**Check Engine MIL - DTC P0121 Flagged –
Connector Material Mismatch –
AJ27 Engines – Modify Harness**

MODEL
1999-2001 MY XK Range
1999-2001 MY V8 XJ Series
VIN
031303-A22860
853936-F40117

ILLUSTRATION 3

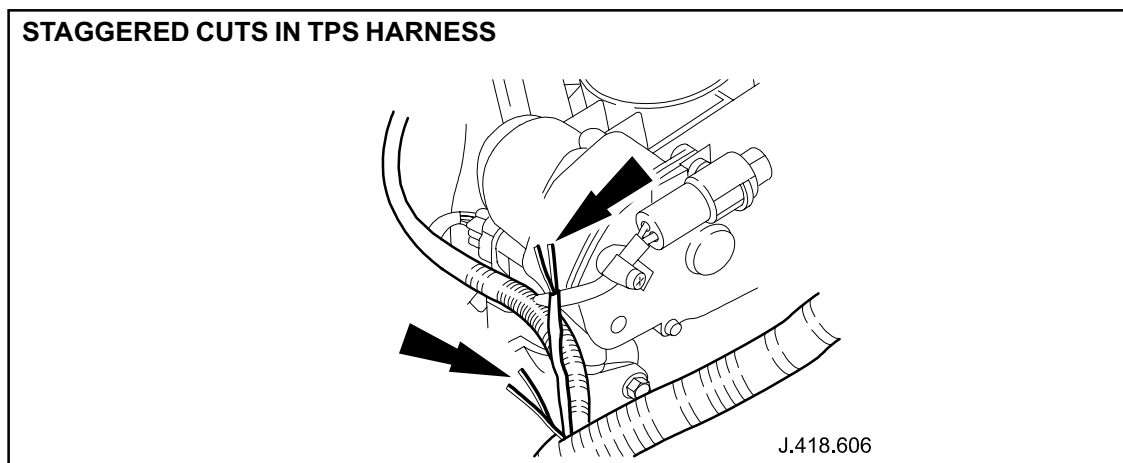
11. Remove the existing tin-plated terminals from the TPS electrical connector.
12. Cut and remove existing tin-plated electrical terminals/wires (Illustration 3).

Note: Make sure to stagger the cuts to allow installation of the convoluted sleeve after modification.

ILLUSTRATION 6

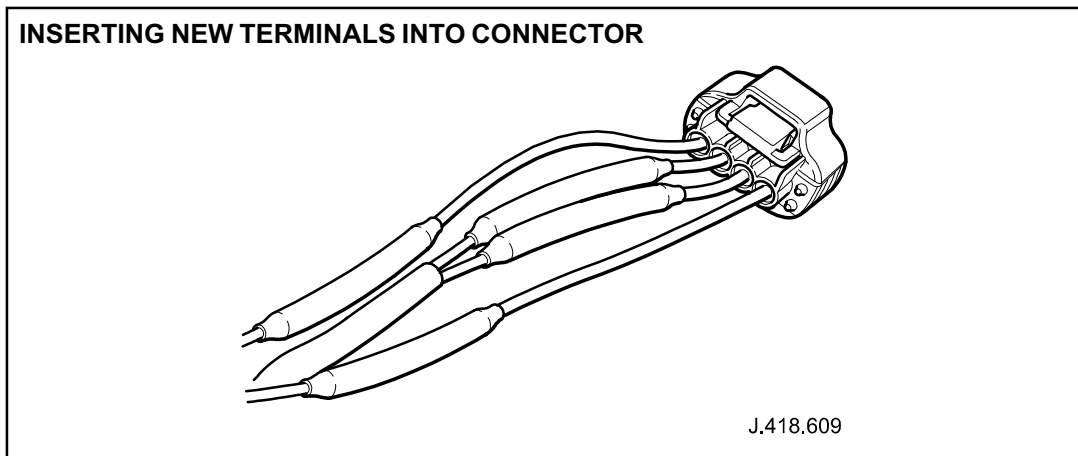
19. Install gold plated electrical terminals (into positions noted at step 9) into TPS electrical connector (Illustration 6).
